# Regarding Comment I-73 on D3.0

Contribution to IEEE 802.3cy

**Han Bi and Ragnar Jonsson - Marvell**

# Explanation of Proposed Bandpass Filter

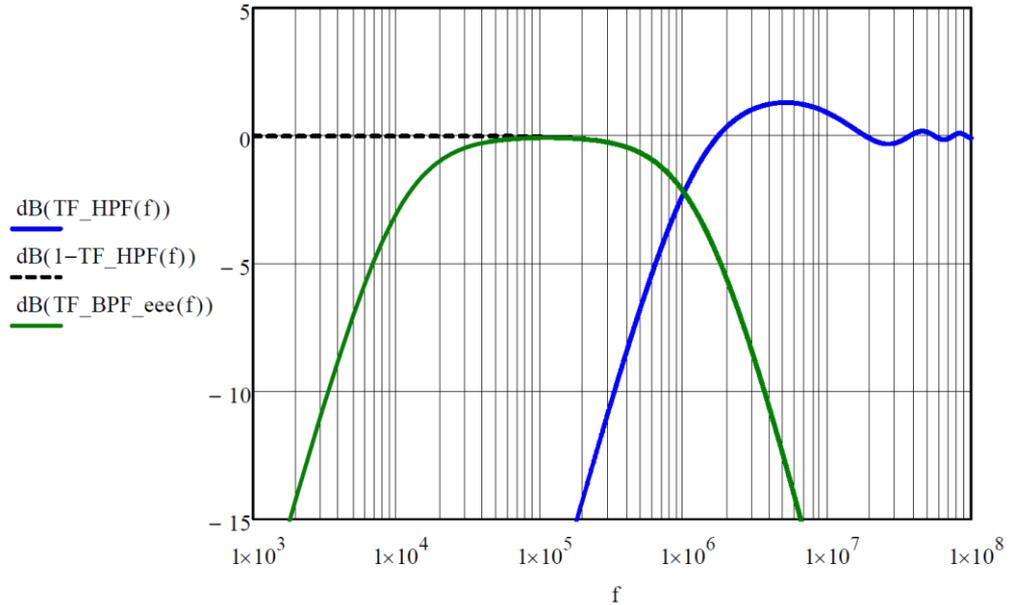
- The bandpass filter is based on High-pass Function in 94.3.12.6.1

$$G_L(f) = \frac{f}{f - j \times f_C} \left( 1 - \frac{f}{f - j \times f_H e^{-j\pi fT}} \right)$$

# Explanation of Proposed Limits

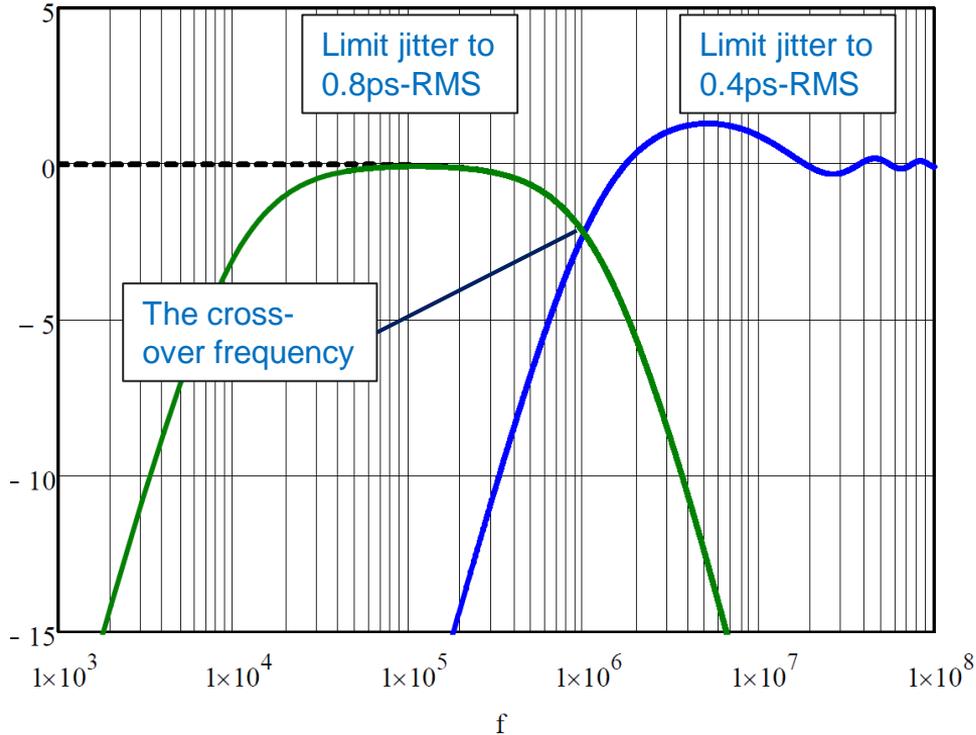
- The 1MHz crossover frequency is a compromise between CDR jitter tracking performance, echo noise, etc. The 1MHz value is intended to be a conservative number that will help with interoperability between different PHY implementations
- The 0.8ps jitter limit in the lower band is a compromise between analog complexity and CDR performance (SNR on long cables and EEE robustness)
